### STAFF REPORT ADDENDUM

### APPLICATION SE 2007-MA-034

**PROPOSAL:** Develop a freestanding drive-in financial institution with two, detached drive-through lanes in a Highway Corridor Overlay (HC) District; and waivers and modifications in a Commercial Revitalization District (CRD).

SUBJECT: THIRD ADDENDUM: SE 2007-MA-034; Commerce Bank  
Land Identification Map: 71-1-((1))-89

**SITE PLAN**

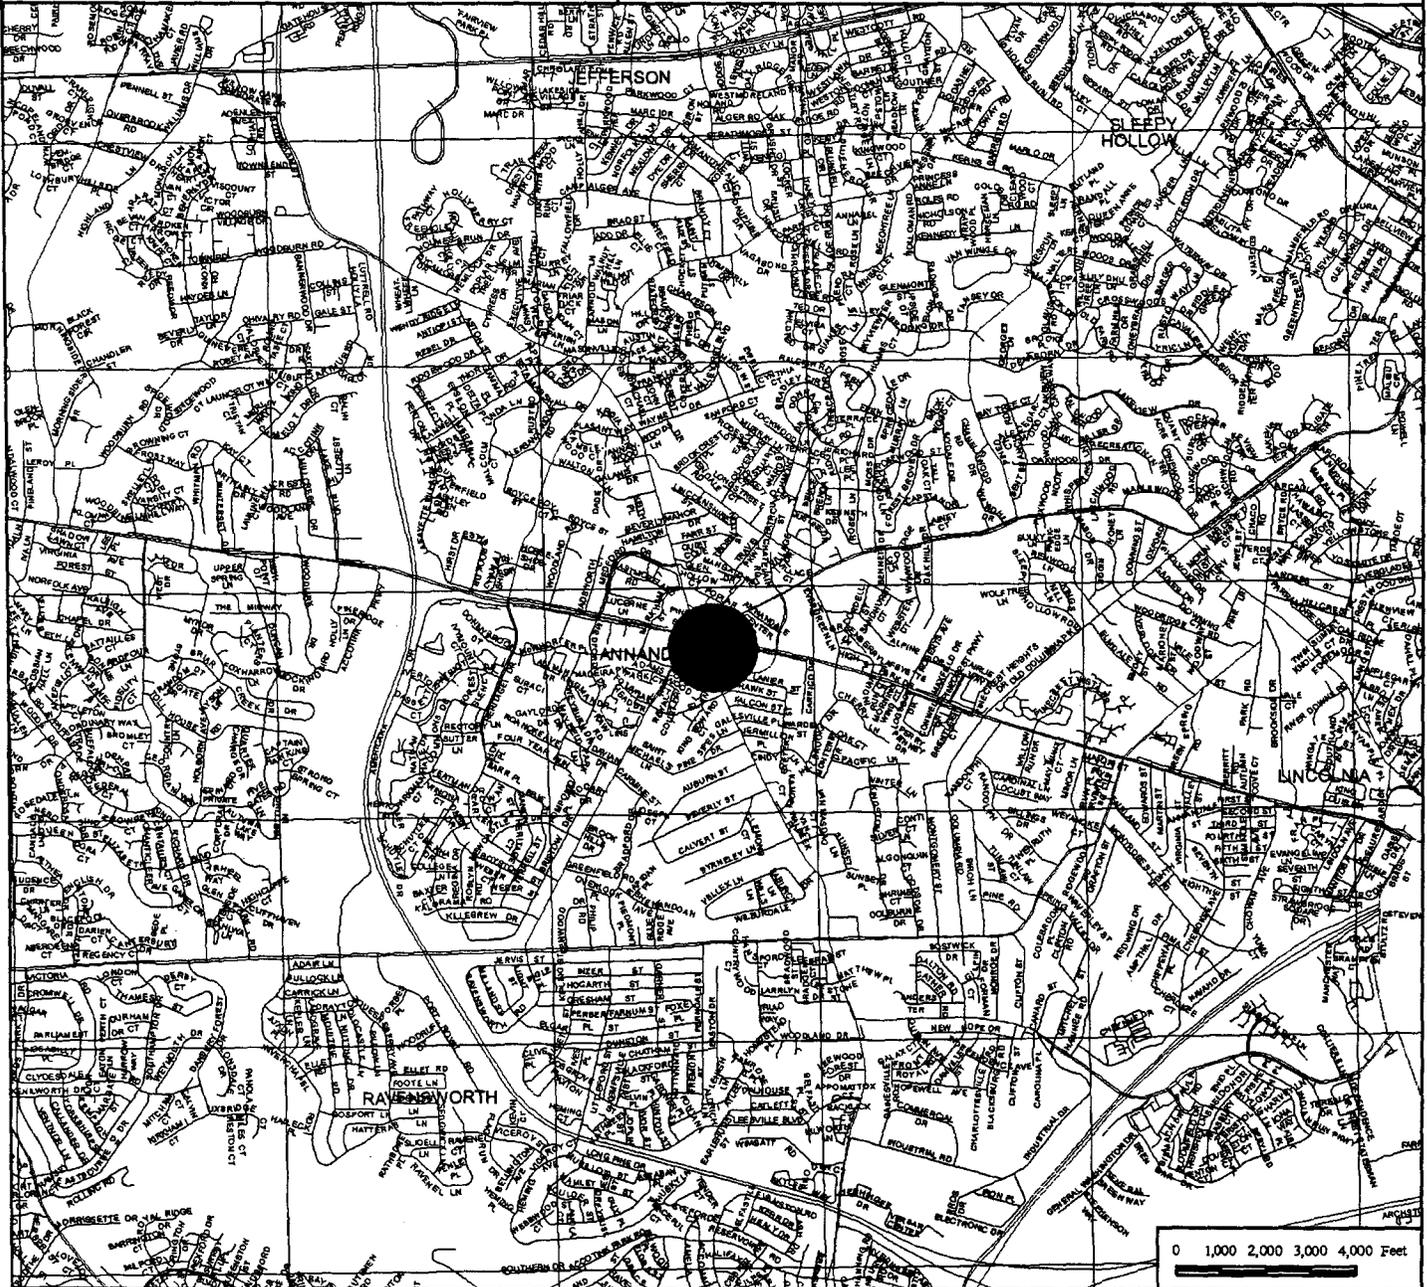
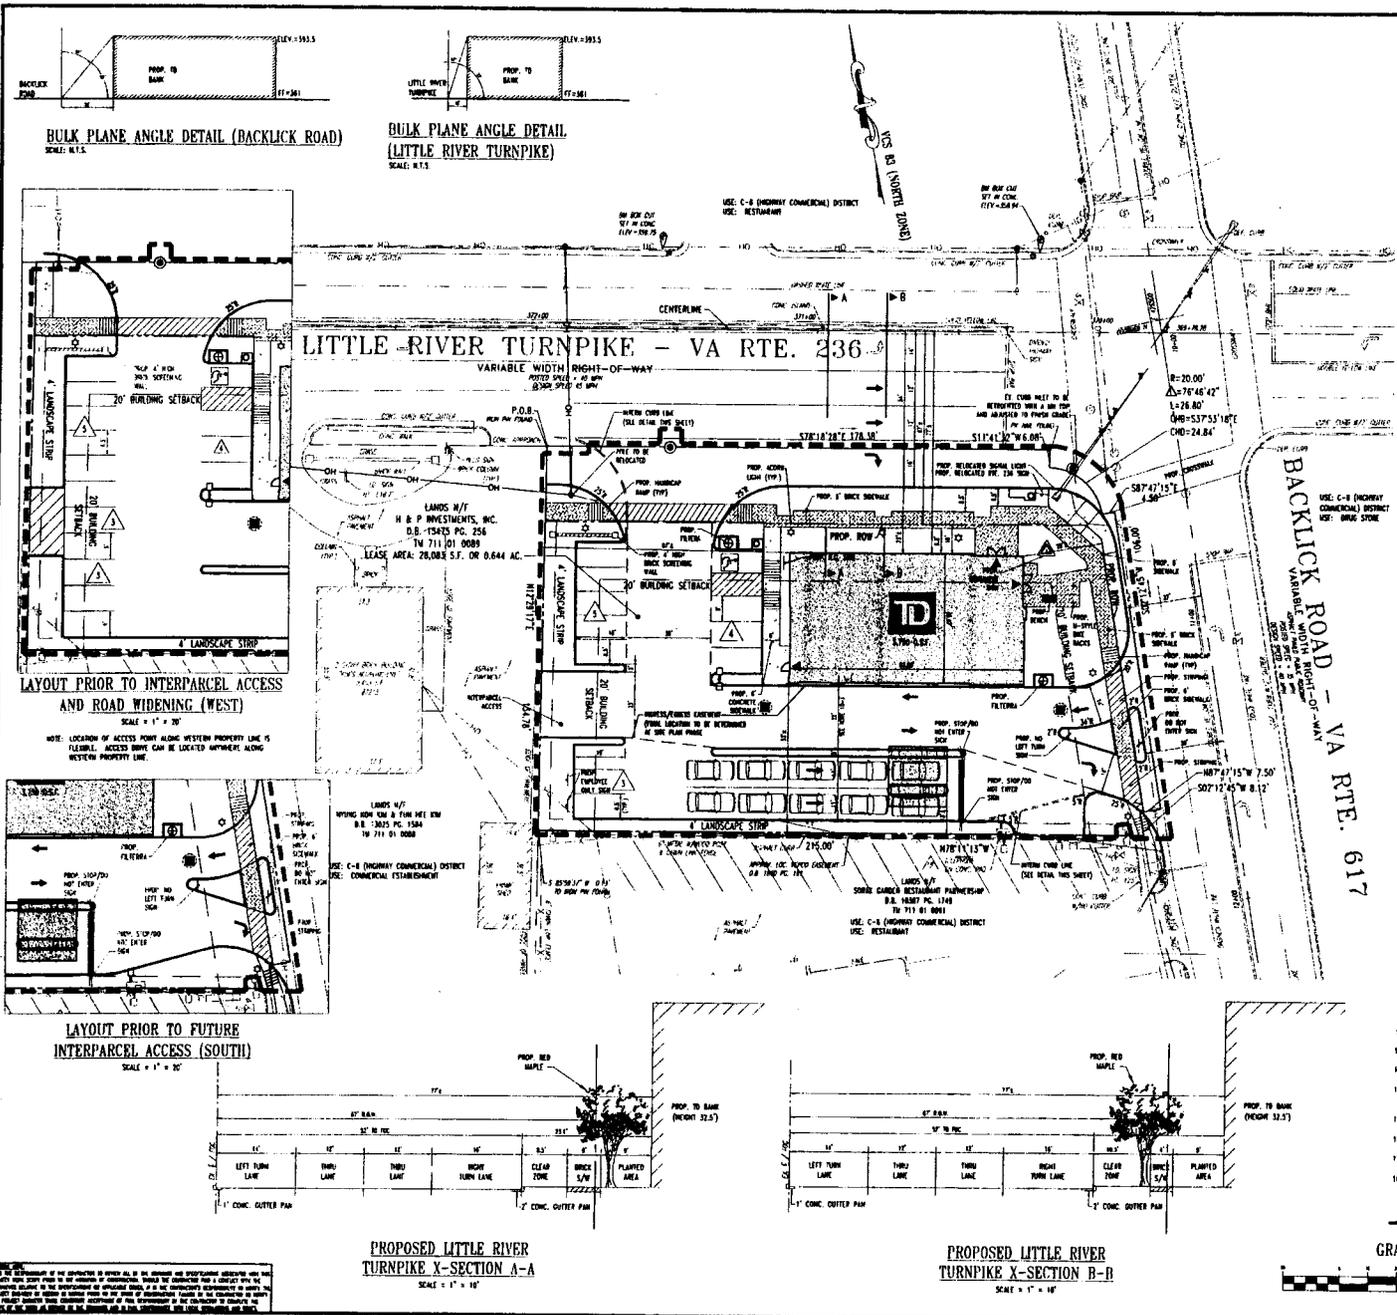
The revised SE Plat retains the general design and layout of the previous SE Plat, with the exception of the entrance on Backlick Road, which has been re-designed to incorporate a channelized island to attempt to discourage left turn movements into and out of the site. The revised SE Plat also corrects a number of previous errors in the tabulations and notes on the plat, although some concerns remain.

Staff continues to believe that the proposed entrance on Backlick Road will negatively impact traffic operations at the Little River Turnpike and Backlick Road intersection. The latest revision depicts a channelized island at this entrance as a method of deterring vehicles from making left turn movements into and out of the site. While this represents an improvement, the island is still not capable of completely prohibiting these

left turn movements. Considering the amount of traffic already traveling through this intersection, the applicant's proposed entrance configuration can be expected to increase left turn queue lengths and wait time for vehicles on Backlick Road. A median on Backlick Road would be the most appropriate traffic device for this section of Backlick Road, and should be pursued by the applicant.

While the new channelized island provides a better alignment between entering and exiting vehicles, a narrower drive aisle as currently shown has the potential to slow drivers entering the site, thereby increasing the delay on the adjacent roadway. Staff continues to strongly encourage the applicant to improve on-site circulation by re-designing the site to place the bypass lane south of the drive-through, and slightly widening the drive aisle.

- The sight distance exhibit for the Little River Turnpike entrance is incorrect. The exiting vehicle point is placed within the proposed right turn lane; the exhibit should be revised accordingly.

- The proposed vegetation is conflicting with sight distance lines at the Backlick Road entrance; this vegetation should be relocated where it will not conflict with sight distance, subject to the approval of UFM.

- The sight distance at the entrance on Little River Turnpike should be verified for both Little River Turnpike as it exists today and as it may be widened in the future.

**LANDSCAPING PLAN**

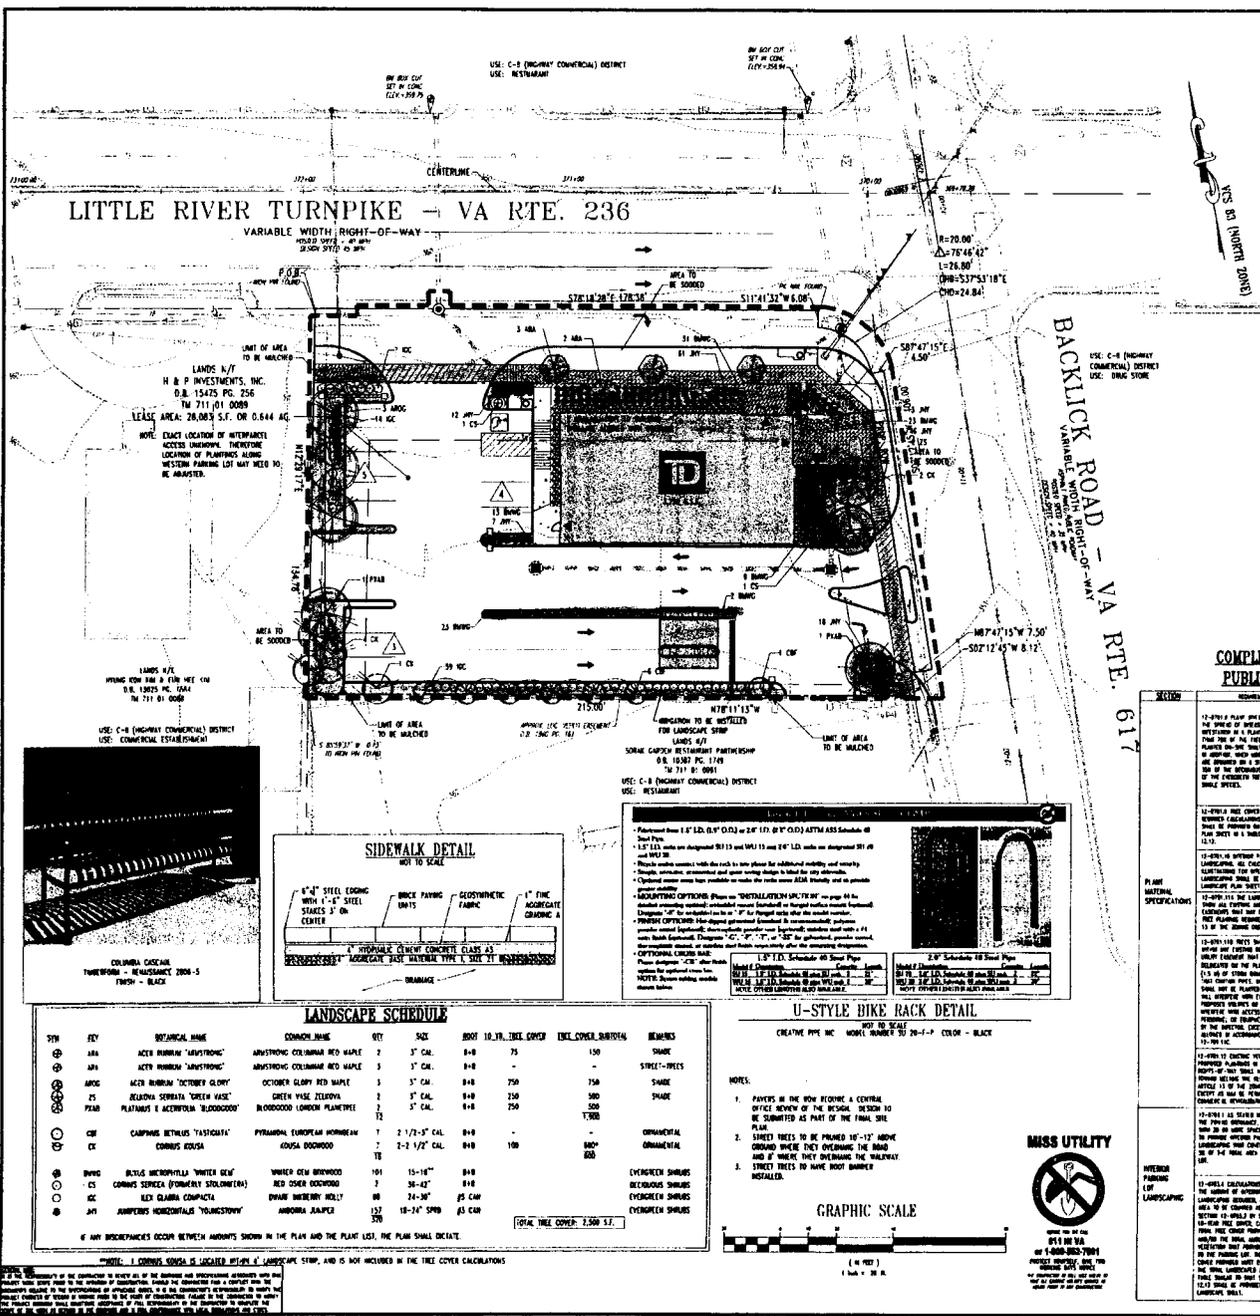
- The landscape strip located along the western property line continues to be labeled as being 4 feet in width and graphically depicted as being 12 feet in width. The plat should be revised to depict a twelve foot wide strip.

12. The landscape strip depicted along the western property boundary shall be a minimum of twelve feet in width, as graphically depicted on the SE Plat, and shall be planted in substantial conformance with the treatment depicted on the SE Plat, as determined by UFM.
